NEW GAS STATION, C-STORE, DRIVE-THRU
A.L. PRIME #TBD
23 CENTRAL STREET
BYFIELD, MASS

THIS SET ISSUED FOR SPR & SP 10/7/20 2nd HRG, W/ REVISIONS PER CMTS

PROJECT
COVER SHEET

SITE LAYOUT

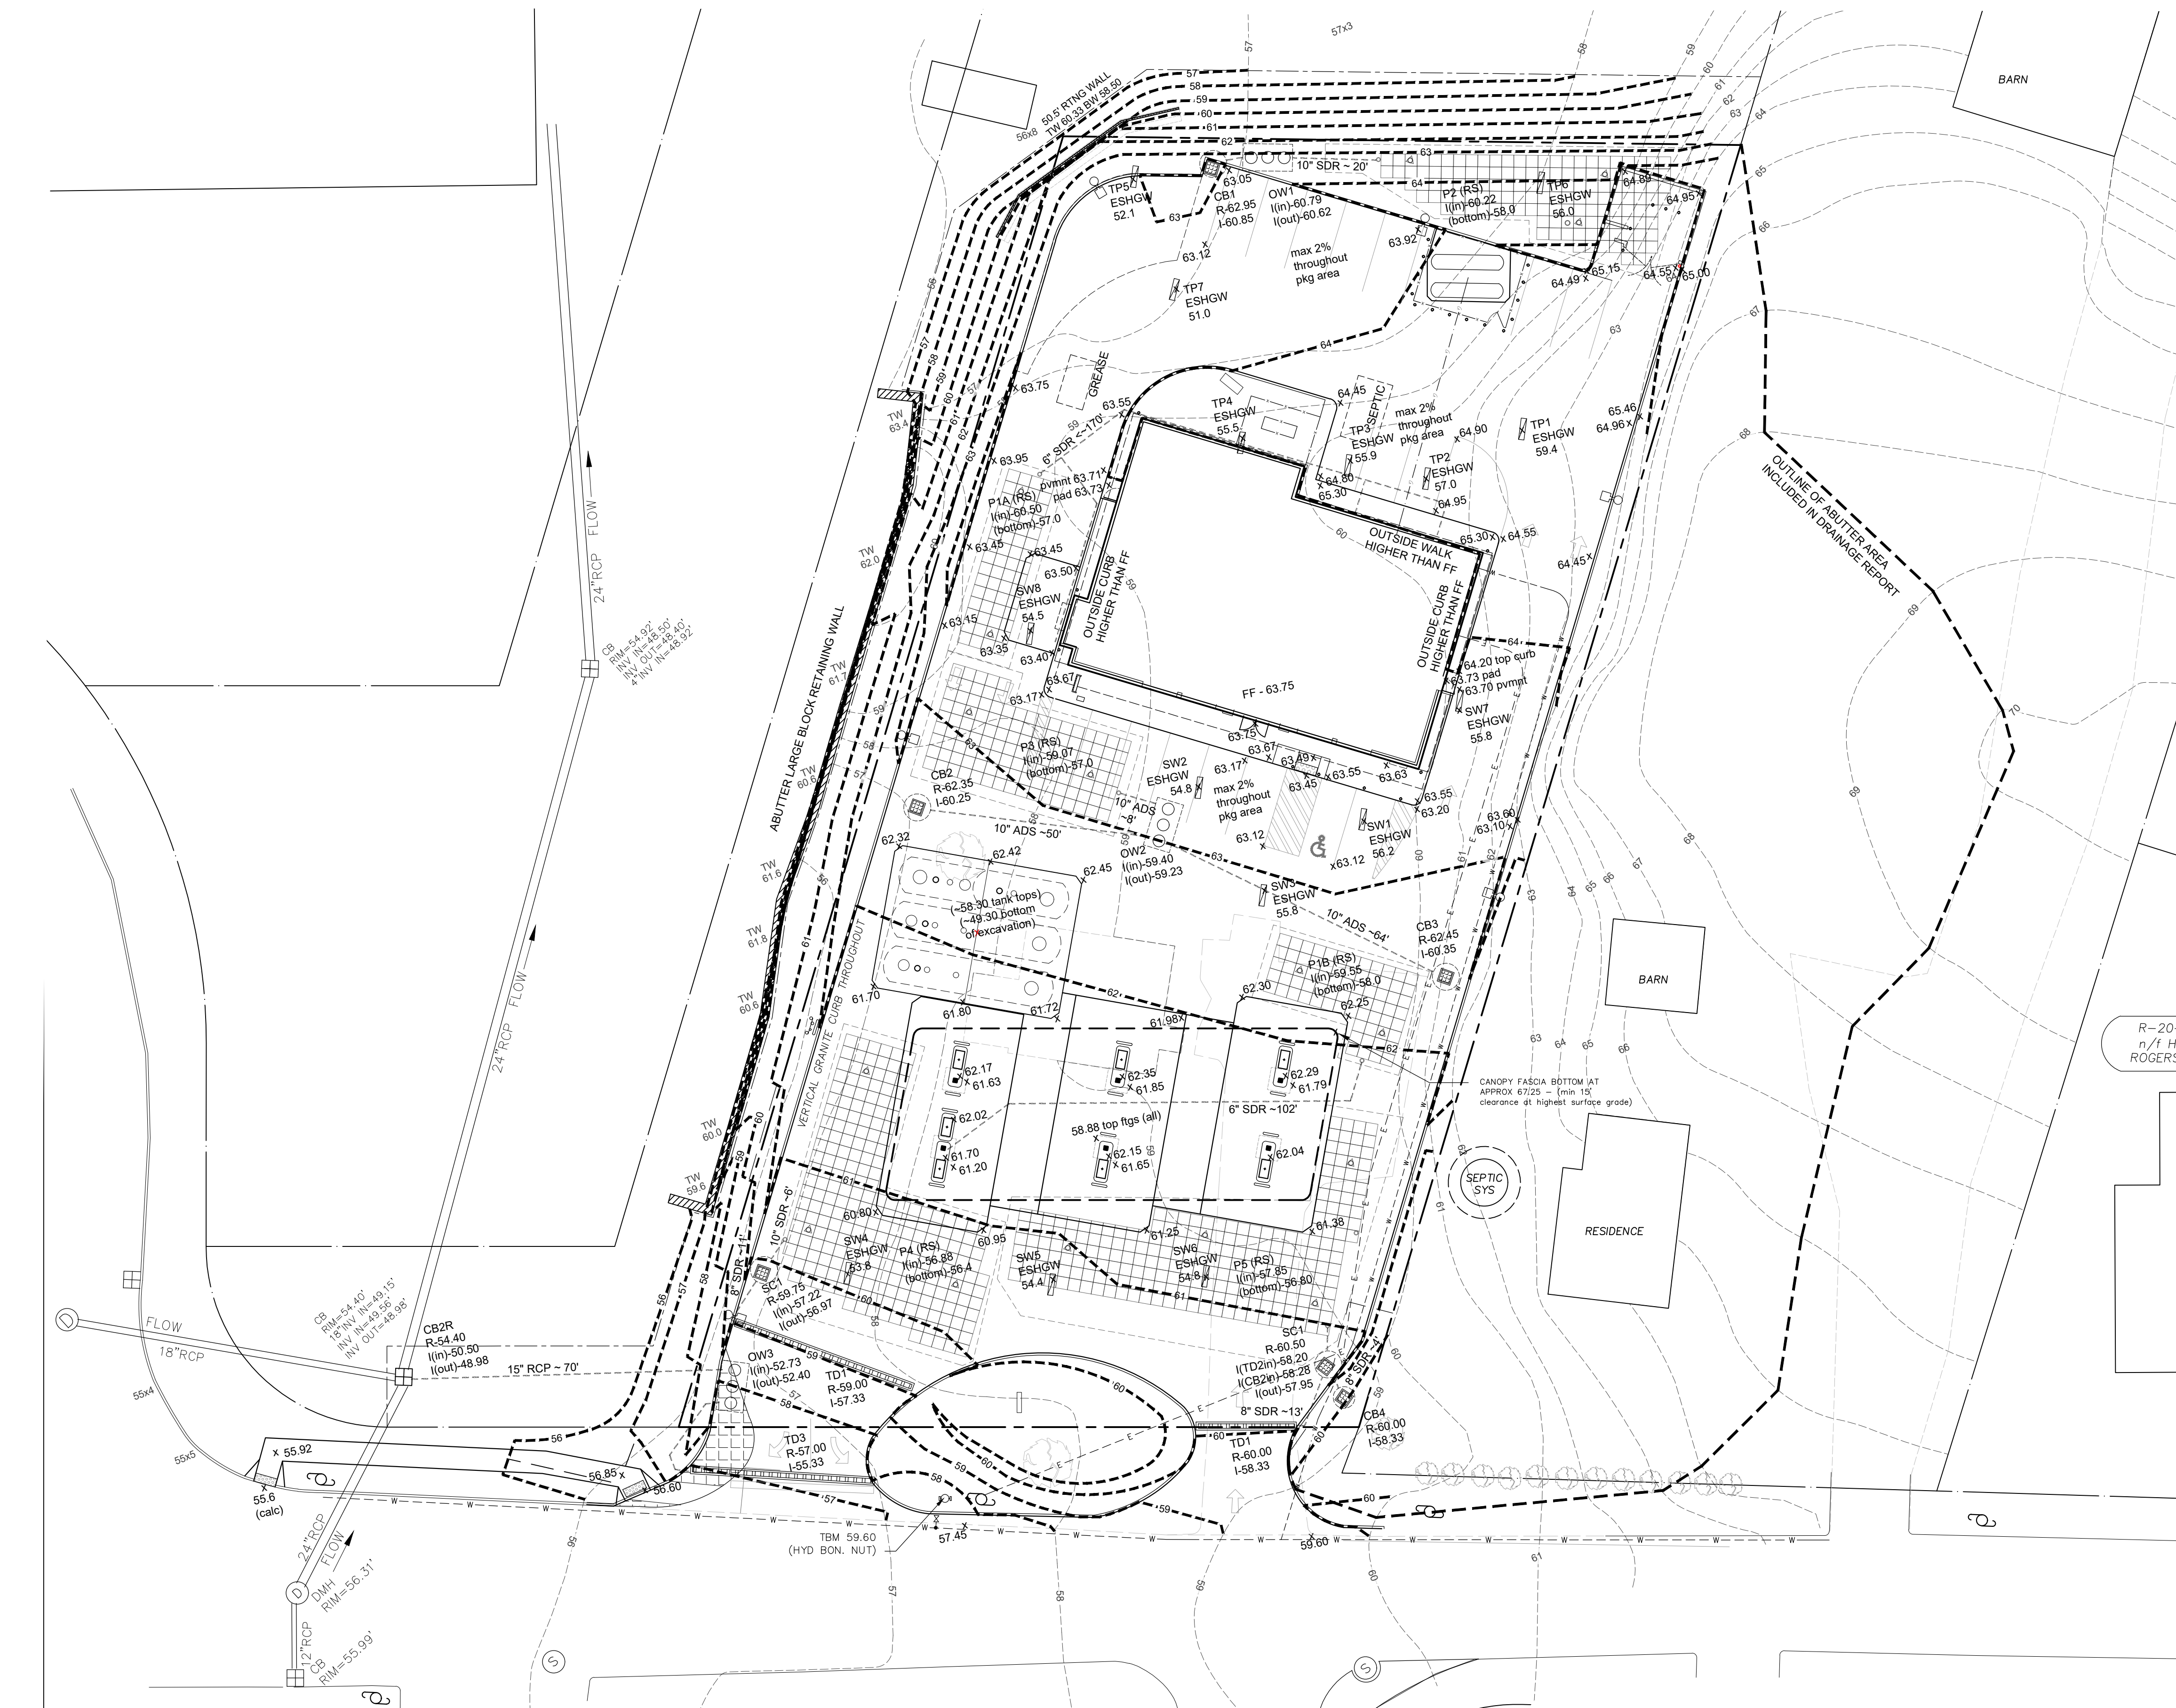
- 9/23 REVISIONS FOR SECOND PLNG BD PUBLIC HEARING
MULTIPLE REVISIONS PER REVIEW AND BOARD COMMENTS, INCLUDING:
1. RAISED FINISHED FLOOR ELEVATION
 2. ADJUSTED ALL SITE GRADING TO RAISE GRADES AROUND BUILDING

3. REDUCED SIZE AND ADJUSTED LOCATION OF RETAINING WALL ALONG WEST PROLINE
 4. ADDED OUTLINE OF PROPOSED GRADING & DRAINAGE EASEMENT
 5. CHANGED SURFACE INFILTRATION AREAS TO SUBSURFACE

6. ADDED AREAS ON ABUTTING PROPERTY UPGRADIENT OF SITE TO STORMWATER CATCHMENT AREAS
 7. REVISED DRAINAGE STRUCTURES, INCLUDING THE ADDITION OF TWO STORMCEPTORS

8. CHANGED DRIVEWAYS TO ONE WAY
 9. REDUCED WIDTH OF DRIVEWAYS
 10. ADDED SIDEWALK FROM DRIVEWAY TO CROSSWALK AT FRUIT ST
 11. CREATED MIN 25' SEPARATION BETWEEN PROPANE AND TRASH

12. ADJUSTED PARKING AROUND RELOCATED PROPANE ENCLOSURE
 13. CHANGED ALL NOTES TO REFLECT VERTICAL GRANITE CURBING THROUGHOUT THE SITE
 14. MOVED ELECT SERVICE FROM OVERHEAD TO UNDERGROUND

15. ADDED PAVEMENT MARKINGS FOR ONE WAY TRAFFIC AROUND STORE
 16. ADJUSTED ROAD STRIPING AND CURBING TO ALLOW BYPASS PER TRAFFIC PEER REVIEW COMMENT
 17. ADDED ADJUSTMENT TO INTERSECTION ALIGNMENT OF CENTRAL STREET AND CENTRAL COURT

18. ADJUSTED LANDSCAPE PER NEW LANDSCAPE ARCHITECT'S PLAN
 19. CONFIRMED ALL PARKING AREAS MAX SLOPE OF 2%
 20. ADDED BIKE RACK PER TRAFFIC PEER REVIEW COMMENTS

21. ADDED AIR TOWER ALONG BUILDING FRONT SIDEWALK
 22. RELOCATED SECOND LOADING ZONE
 23. ADDED PARKING SPACE NUMBERING
 24. ADDED PARKING SPACE DIMENSIONS

25. SIDEWALKS LABELED AND DIMENSIONED
 26. PAVEMENT AND CURB OFFSETS TO PROPERTY LINES ADDED
 27. MANUEVER AISLE WIDTHS ADDED
 28. CURB RADII ADDED
 29. CHANGED STORE ROOF FROM FLAT TO PITCHED ROOF AND CHANGED WALL SECTION FROM ALL SPLIT FACE BLOCK TO PARTIAL BLOCK, PARTIAL WOOD FRAMING

GRADING

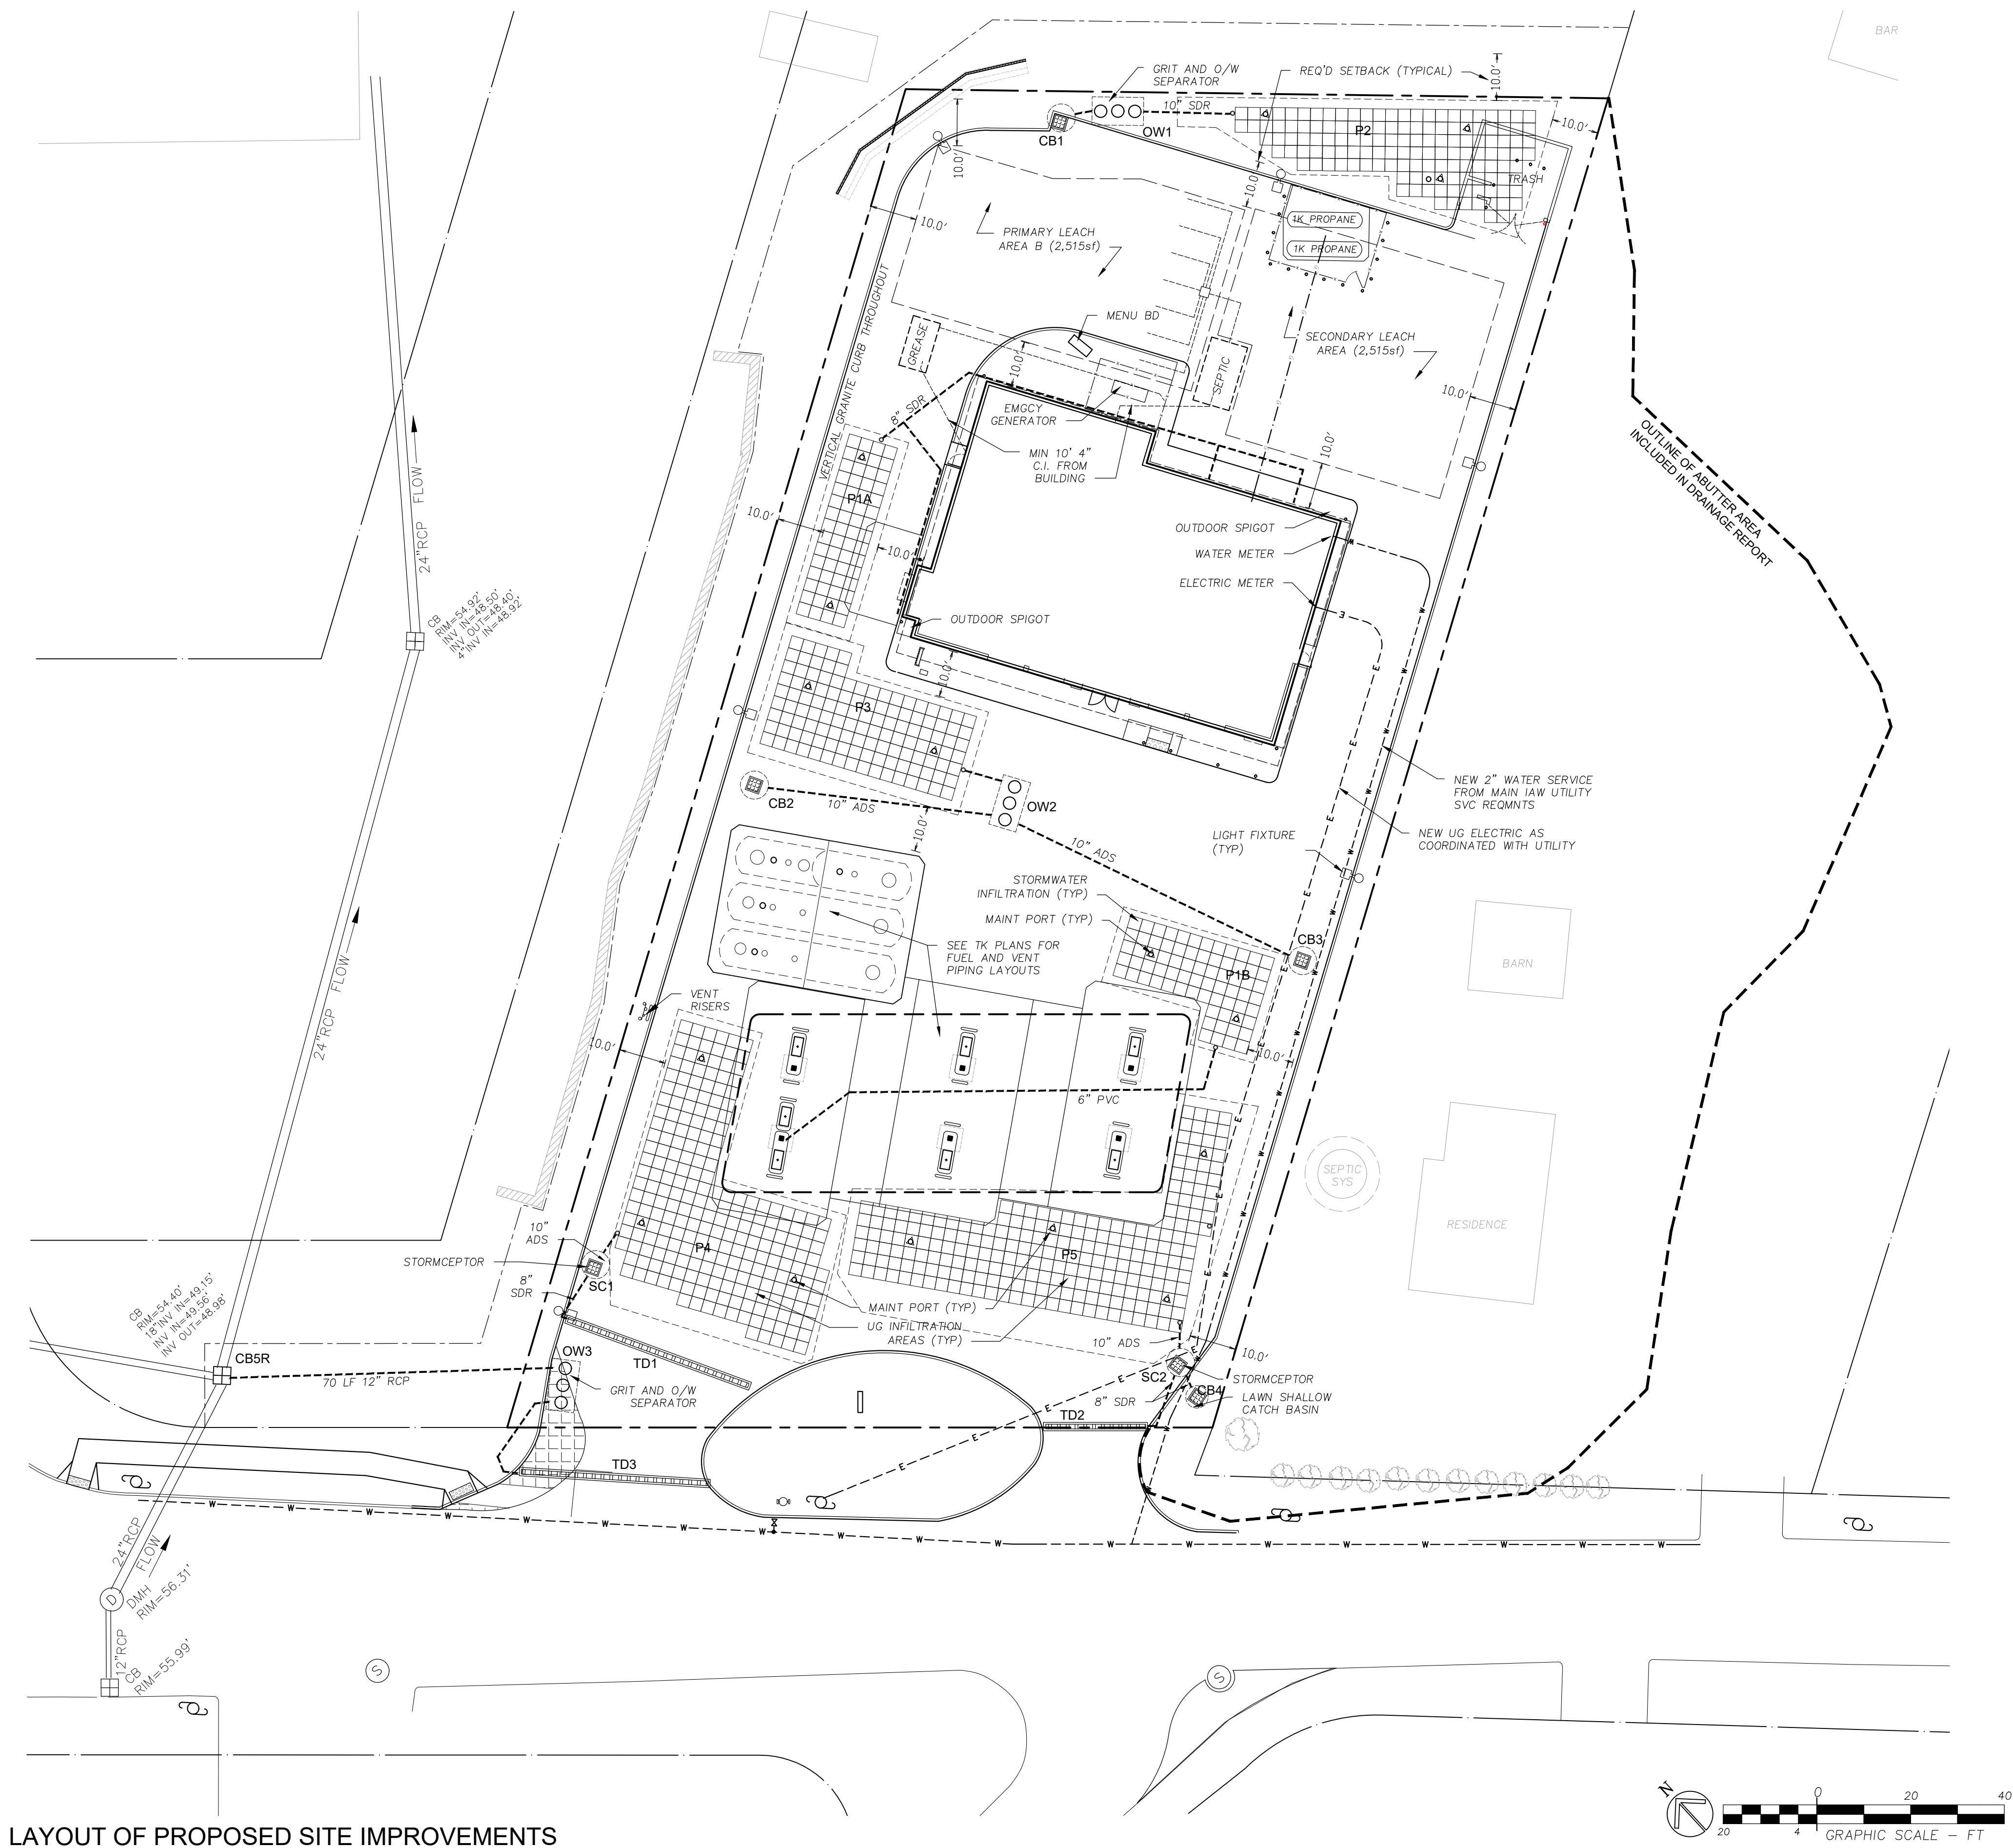
| DATE | REV | DESCRIPTION |
|------------|-----|--|
| 09-23-2020 | 1 | AG ADDED ABUTTER CONTOURS, RAISED FF AND REAR PWINT GRADES 2'-3" |
